AGENDA
PLANNING AND ZONING COMMISSION MEETING
CITY OF CREVE COEUR, MISSOURI
MONDAY, JULY 6, 2020
6:30 PM

1. Application #20-016: Minor Site Plan for New LED Drive and Pedestrian Lighting for the Bayer East and West Creve Coeur Campus at 800 Lindbergh Boulevard and 10300 Olive Boulevard

**APPLICATION TO PLANNING AND ZONING COMMISSION
#20-002 & #20-010: BOUNDARY ADJUSTMENT, SITE DEVELOPMENT
PLAN AND CONDITIONAL USE PERMIT FOR QUIKTRIP GAS STATION
WITH CONVENIENCE STORE AT 11004, 11026, AND 11032 OLIVE
BOULEVARD AND 825 AND 827 GRAESER ROAD, AND THE
REDEVELOPMENT OF THE ADJACENT RETAIL CENTER
AT 11032 AND 11056 OLIVE BOULEVARD**

REQUEST: Gwen Keen, Real Estate Project Manager, QuikTrip Corporation, has submitted an application for a Conditional Use Permit and Site Development Plan at 11004, 11026, 11032 and 11056 Olive Boulevard and 825-827 Graeser Road, for a new gas station with convenience store, that includes the redevelopment of the adjacent retail center at 11032 and 11056 Olive Boulevard. Gasoline Stations with Convenience Stores (NAICS 447110) require a conditional use permit in the GC-General Commercial District subject to a public hearing and recommendation of the Plannin

Figure 2: Close-up of the Preliminary Demo Plan showing the location of the new entrance with the existing curb cuts, and the GIS image of the existing area.

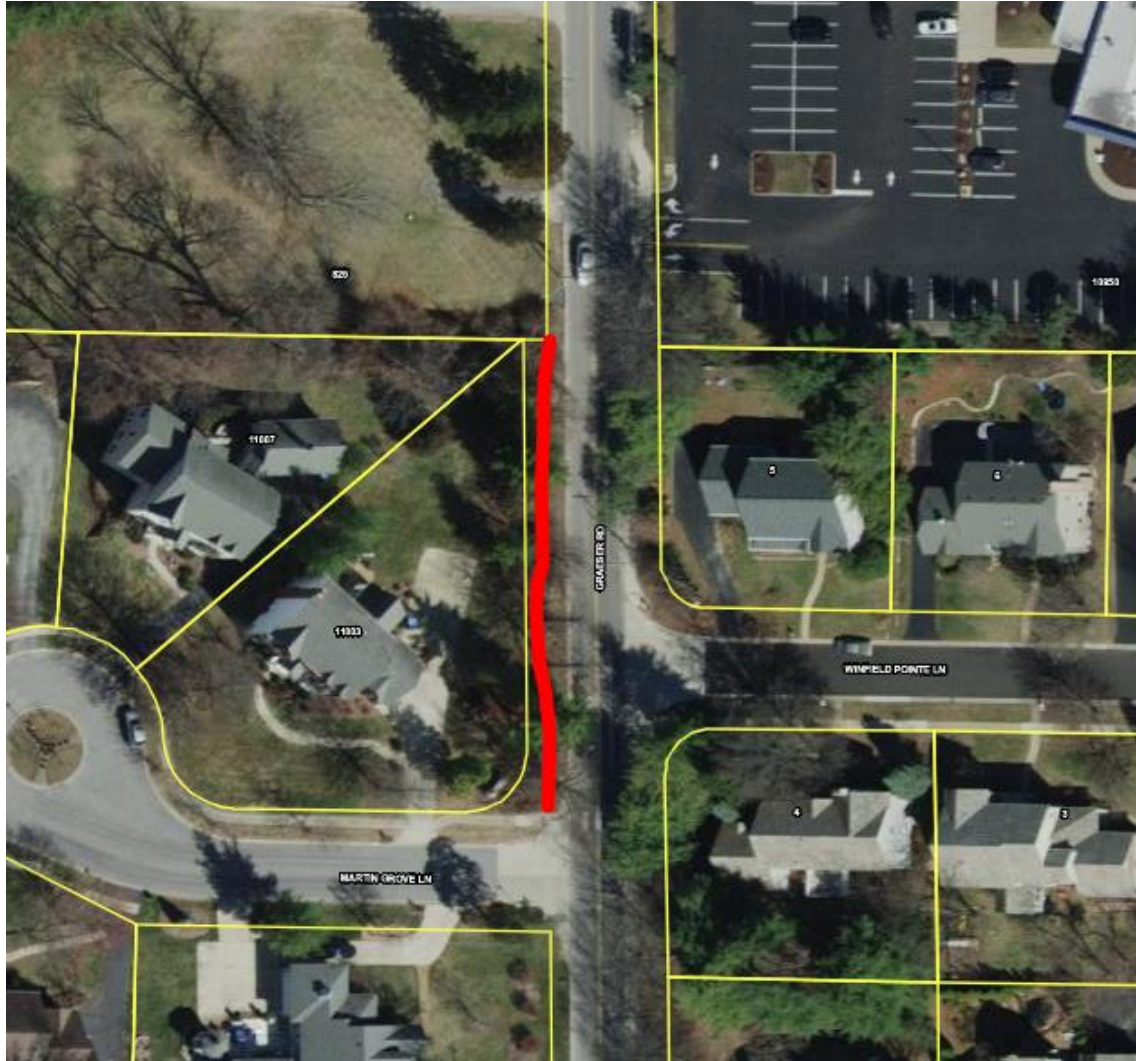
The site development plans submitted on May 11th, show that the proposed Graeser entrance curb cut is located between the two existing driveways for 825 and 827 Graeser Road, reducing the three curb cuts into one. CBB’s letter indicates that this location aids in the traffic impacts. Staff would note that it is considered a best practice to locate vehicular access points furthest from the intersection as possible and this appears to be the case with this proposal.

Figure 10: Close-up of the site plan showing the main entrance.

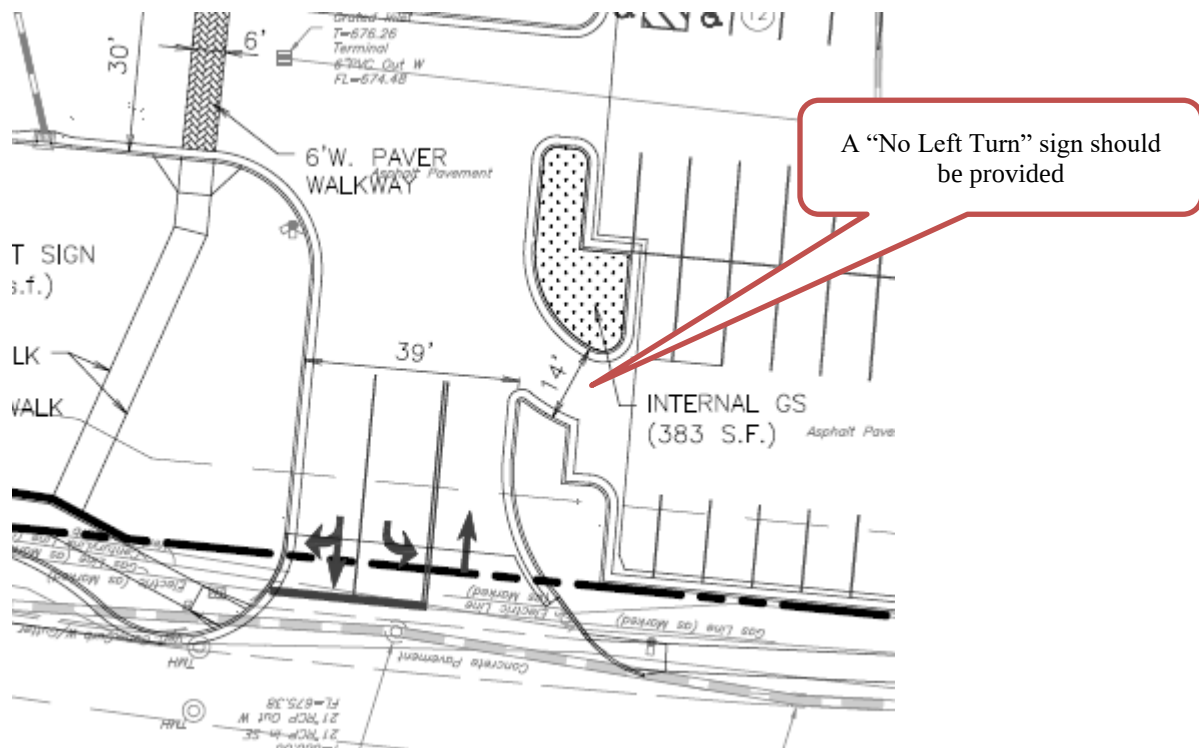
- Access to all service stations should be limited to 2 curb cuts. If at a corner, there should be no more than 1 curb cut per street. Raised planters should be used at various locations to ensure customer safety. The retail center shows the maintenance of the existing entrance that will serve both the gas station and the retail center as a full access. The gas station property is limited to the right in and right out only on Olive, and one access along Graeser Road. MoDOT has concurred with this layout due to the island within Olive Boulevard and the proximity to the intersection. Staff does recommend that a “No Left Turn” will be needed for the parking lot exit. Additional landscaped areas have been provided that are properly curbed within the retail center parking lot, as well as curbed landscape areas for the walkway in front of the C-store. A retaining wall and landscaping are provided between the parking and the new sidewalk along Graeser Road, to comply with these recommendations.

Figure 22: Close-up of the Photometric Plan showing lighting levels underneath the Canopy Structure with the highest levels circled in red.

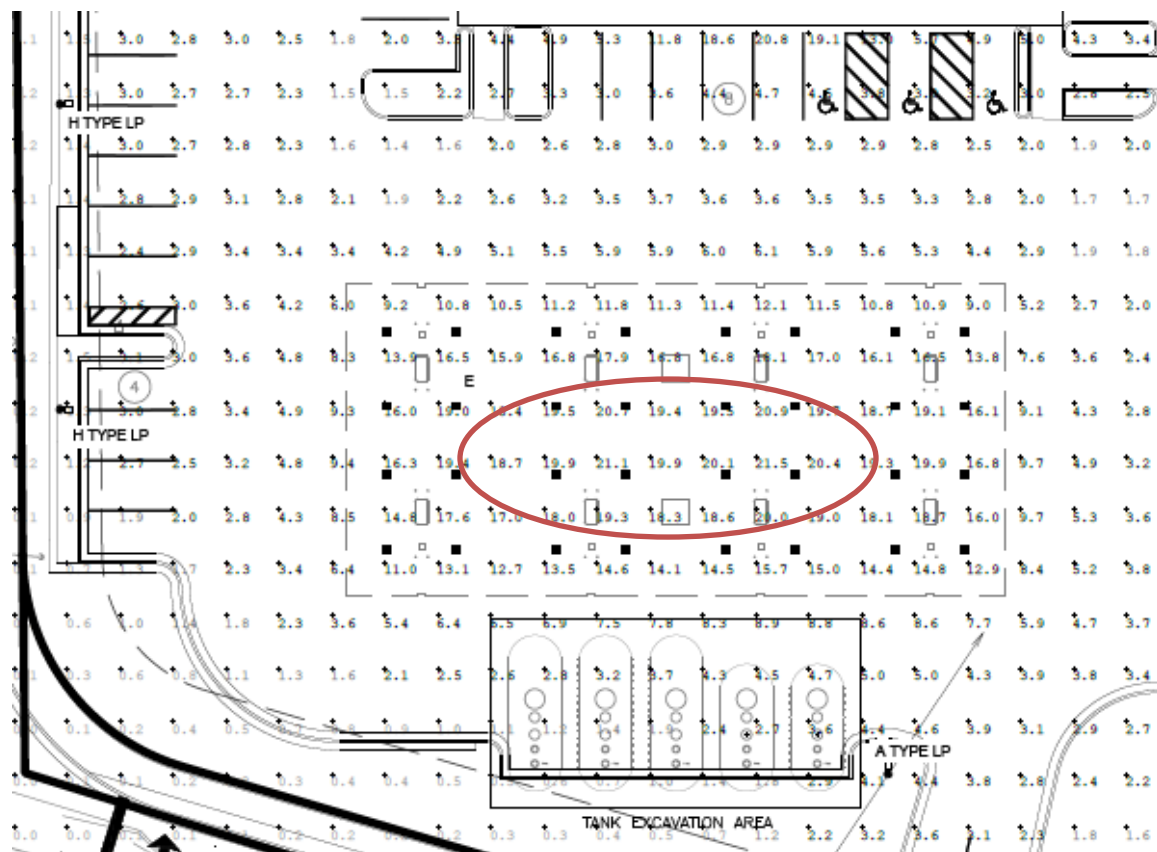
The photometric plan is showing the lighting between the hours of 10:00 P.M. and 6:00 A.M. to comply with the prior requirements. The Photometric plan is showing levels at a maximum of 21.5 underneath the canopy structure, and now light directed outward or onto adjacent property The Applicant has indicated that it will remain at this level during operational hours.

Figure 25: Close-up of the Boundary Adjustment Plat

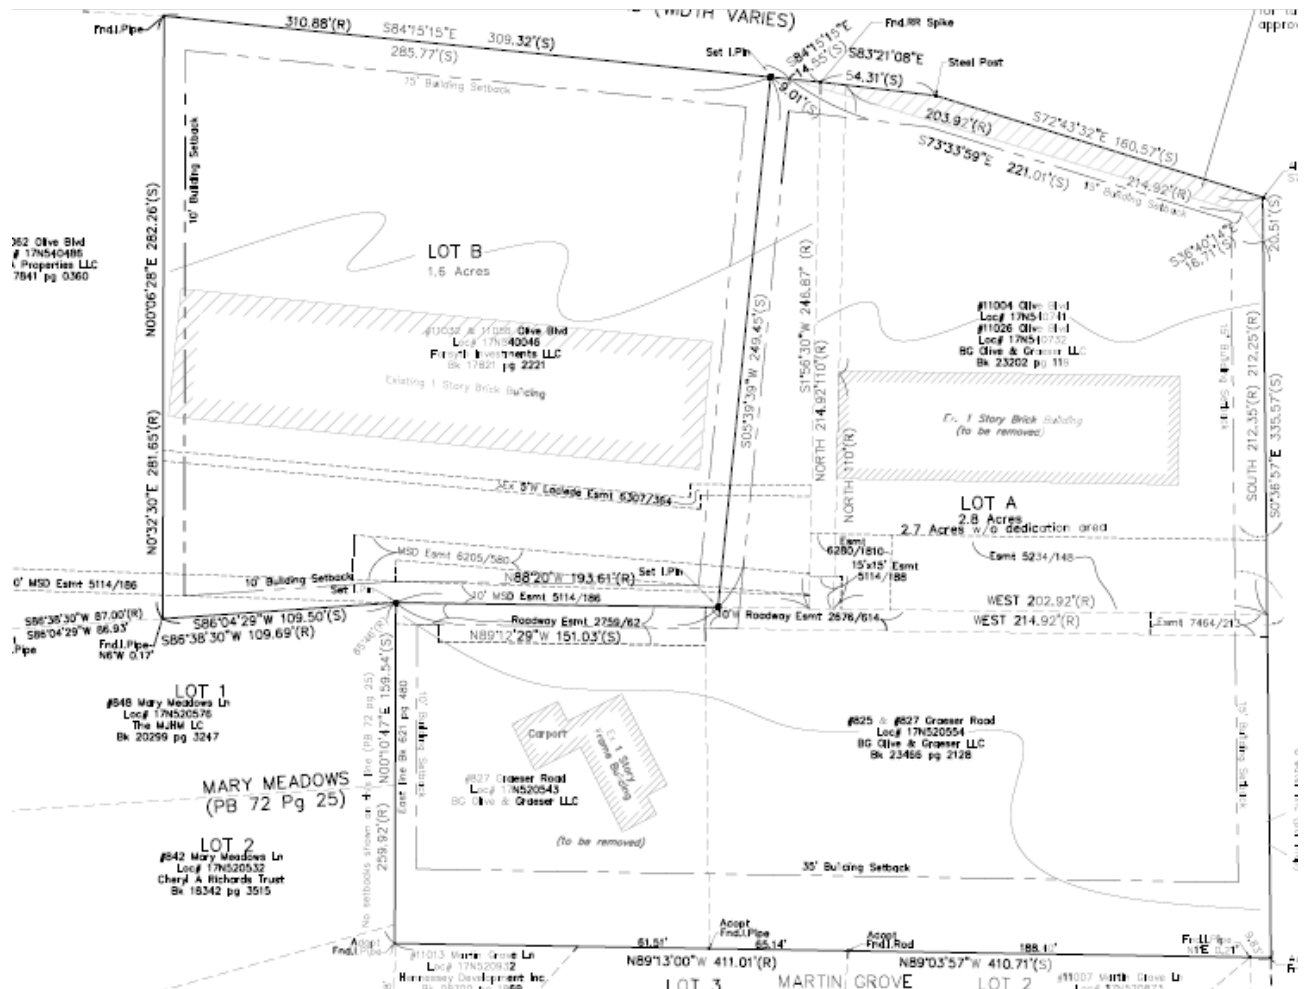
Adjustment Plat, the Site Development Plans and landscape plan is needed with the correct information, including site data tables.

Figure 4: Close-up of the photometric plan for the Bayer West Campus

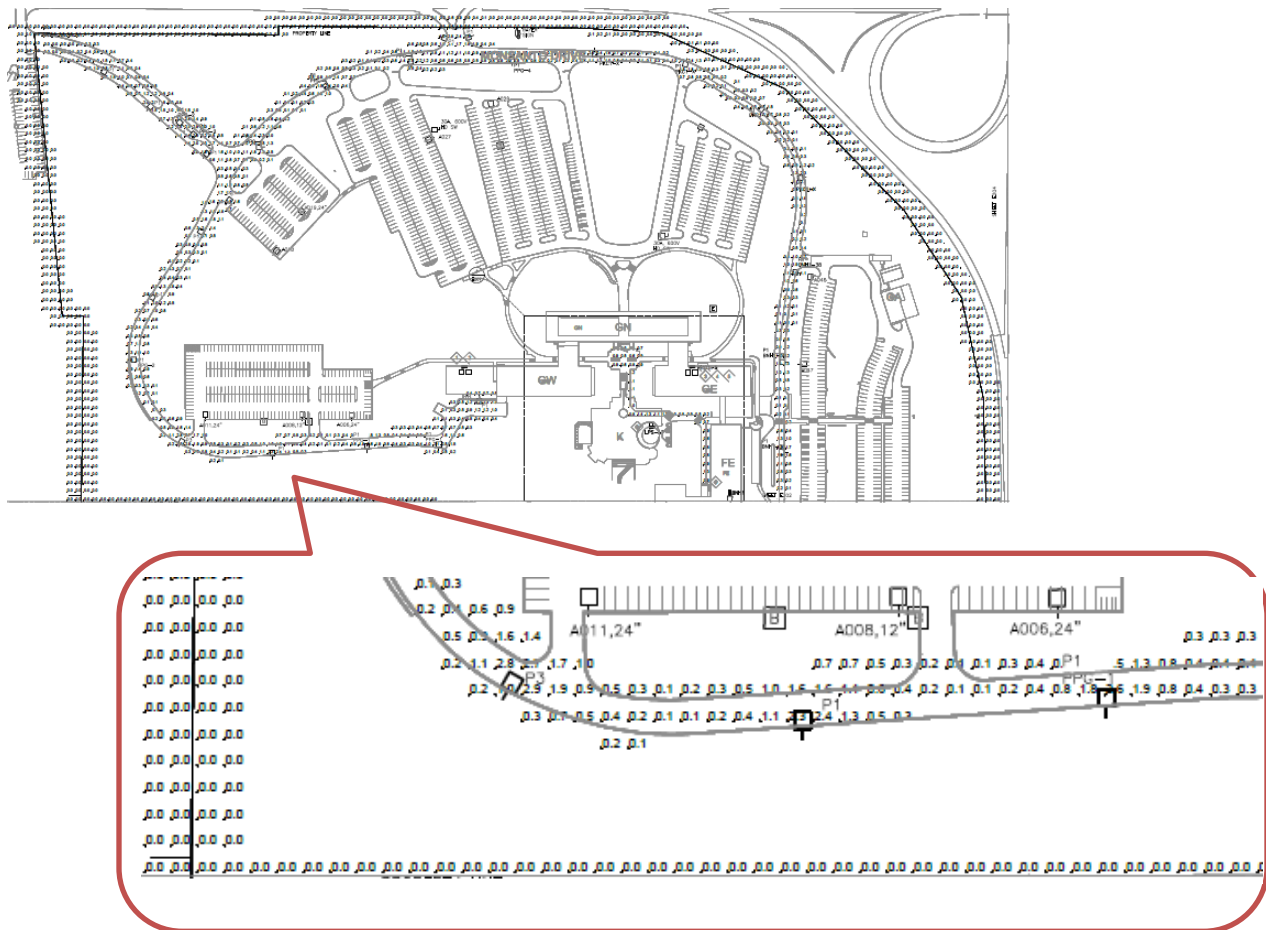
Figure 5: Close-up of the photometric plan of the Bayer East Campus showing the lighting levels at the south property line adjacent to residents and along N. Warson Road.
